SUN-TEC CORPORATION BUILDING EXPANSION JSP15-12

Approval at the request of Sun-Tec Corporation, Inc for approval of the Preliminary Site Plan and Stormwater Management Plan. The subject property is located in Section 9, north of West Road and west of West Park Drive on Lot 14 in Beck North Corporate Park campus in the I-1, Light Industrial District. The subject property is approximately 1.8 acres and the applicant is proposing to expand the existing 20,532 square foot building by 19,718 square foot along with associated parking and landscape.

Approval/Denial of the Preliminary Site Plan and Stormwater Management Plan.

Sun-Tec Building Expansion

Title:
Landscape Plan

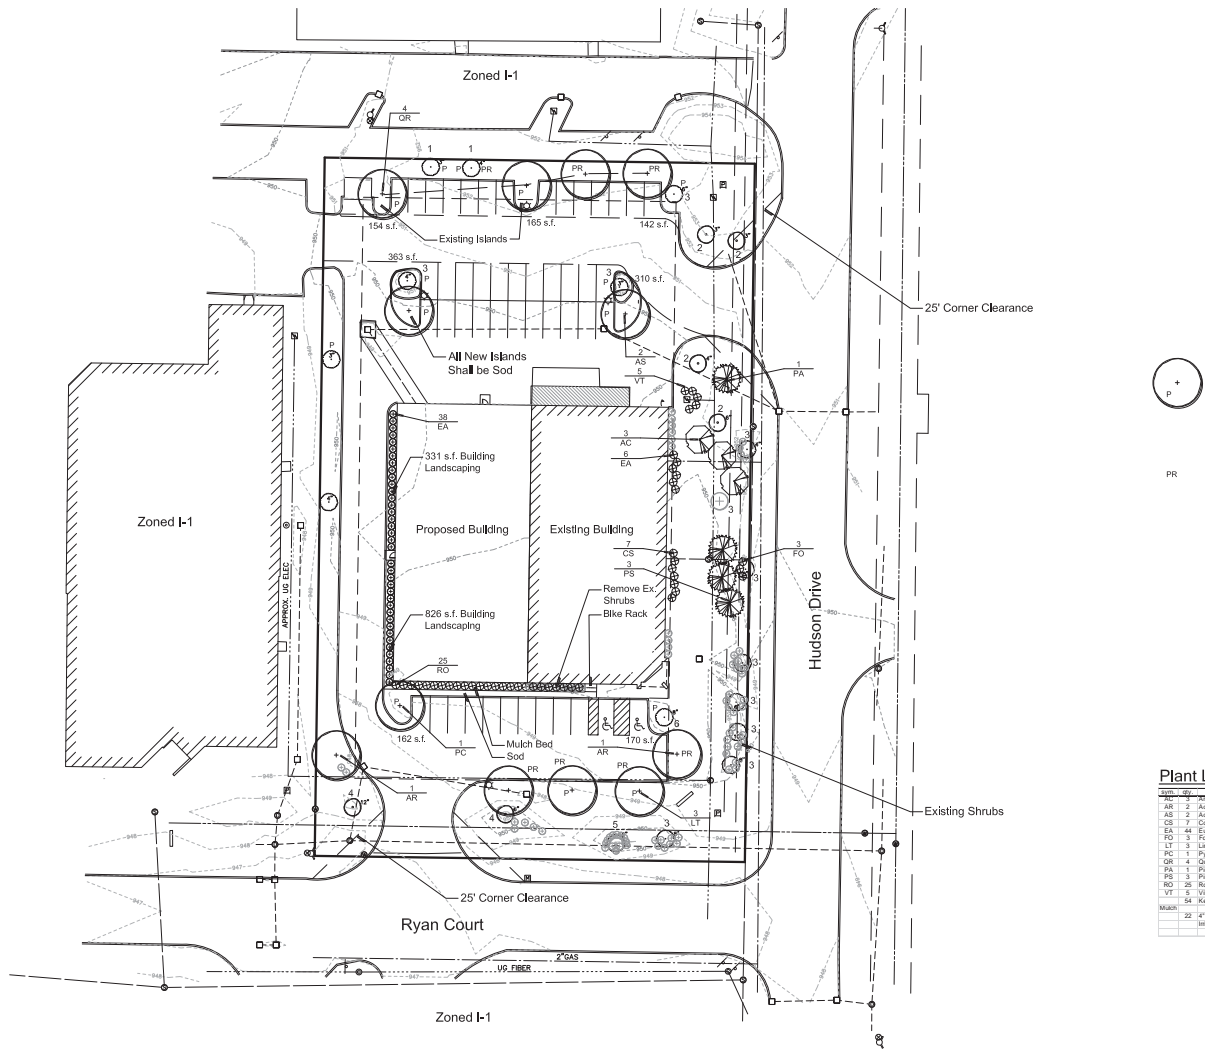
1. Provided.
2. **Please shift the 3 proposed Tuliptrees (LTs) to the east of the catch basin to remove the conflict of the western tree with the existing storm line and add 1 more LT west of the existing White Pine.**

1. No woodland trees. Most existing landscape trees are located and identified.
2. **Please identify two existing trees along western property line.**
3. **Show tree fencing at Critical Root Zone (1' beyond dripline) for all existing trees to remain in work area.**
4. **Add tree protection fencing detail with fence located at Critical Root Zone (1' beyond dripline).**

1. Based on the vehicular use areas, 1,056 sf of islands and 14 trees are required. 1,466 sf of islands and 14 trees, including 4 existing canopy trees, are provided.
2. **Please remove PR labels from trees which are designated as P trees.**

1. **The combination of existing and proposed shrubs along the east and south sides of the building meet the 60% requirement.**
2. **The applicant is asked to move the proposed new 7 dogwood shrubs north and/or south to be more visible from the road.**
3. **Please indicate what landscape area(s) on the site is(are) used to provide the 1157 sf landscape area for foundation plantings.** As this is a tight, existing site, the proposed configuration is acceptable.

1. Utility at northeast corner of building is satisfactorily screened.
2. **Utility box at northeast corner of lot should be screened unless applicant learns from utility that they won't allow screening. If that is the case, a note to that effect needs to be added to the Landscape Plan.**

1. Planting details are provided.
2. **Add tree protection fencing detail.**

1. **Snow deposit areas should be indicated on plan..**

1. No woodlands exist on the site. No trees are to be removed.
2. **Tree fencing for existing trees to be saved should be added, at 1' outside of the tree(s) driplines.**

- *Comment: Please shift the 3 proposed Tuliptrees (LTs) to the east of the catch basin to remove the conflict of the western tree with the existing storm line and add 1 more LT west of the existing White Pine.*
Response: The trees indicated above will be relocated on the Final Site Plan.
- *Comment: Please identify two existing trees along western property line.*
Response: The two existing trees along the western property line will be identified on the Final Site Plan.
- *Comment: Show tree fencing at Critical Root Zone (1' beyond dripline) for all existing trees to remain in work area.*
Response: Tree fencing will be shown on the Final Site Plan.
- *Comment: Add tree protection fencing detail with fence located at Critical Root Zone (1' beyond dripline).*
Response: A tree protection fencing detail will be added on the Final Site Plan.

- *Comment: Please remove PR labels from trees which are designated as P trees.*
Response: The PR labels will be removed on the Final Site Plan.
- *Comment: The applicant is asked to move the proposed new 7 dogwood shrubs north and or south to be more visible from the road.*
Response: The proposed 7 dogwood shrubs will be moved on the Final Site Plan.
- *Comment: Add tree protection fencing detail.*
Response: A tree protection fencing detail will be added on the Final Site Plan.
- *Comment: A snow deposit areas should be indicated on plan.*
Response: A snow deposit area will be indicated on the Final Site Plan.
- *Comment: Tree fencing for existing trees to be saved should be added, at 1' outside of the tree(s) driplines.*
Response: Tree protection fencing will be added on the Final Site Plan.
